Hydropower installation at Little Paxton, St Neots

HYDROLOGY ANALYSIS: UPDATED / REVISED Aug 2023

6th September 2023

Environment Agency – Hydrology Team comments

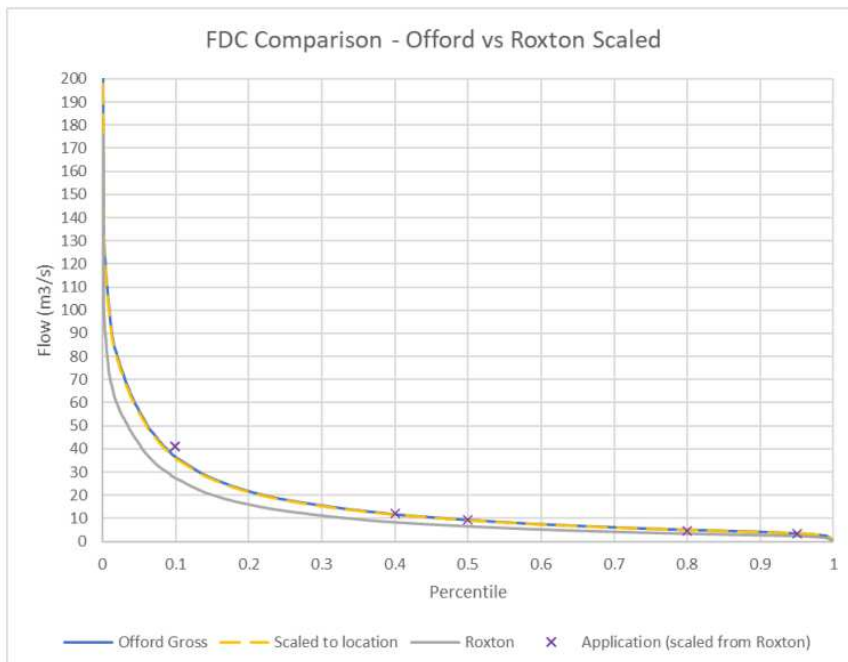
III. Is the flow data flow data provided acceptable? If not, please provide guidance as to what statistics to use and from where. What support information is required to validate/support this data, i.e., what level of detail is required (number of spot flows etc)? Please confirm if you need flow split.

The applicant (in Hydroplan 2022a) has used Roxton to estimate the flows when scaled up. The graph below shows the Flow Duration Curves for Roxton, Offord (Gross) and then the scaled data from the application and scaled data for Offord for comparison. Whilst the shapes are not too dissimilar overall, there is discrepancy in the higher flows and as flows from Offord (Gross) include additional tributaries such as the Kym which join the main river before the application point I feel that the Offord data would be more appropriate. As such I have used the data from Offord (Gross) for the flow calculations required.

Acknowledged. Our revised report (below) now instead uses Offord Gross DMF data, as recommended above, when making application for the licensed flow regime. The 30-year
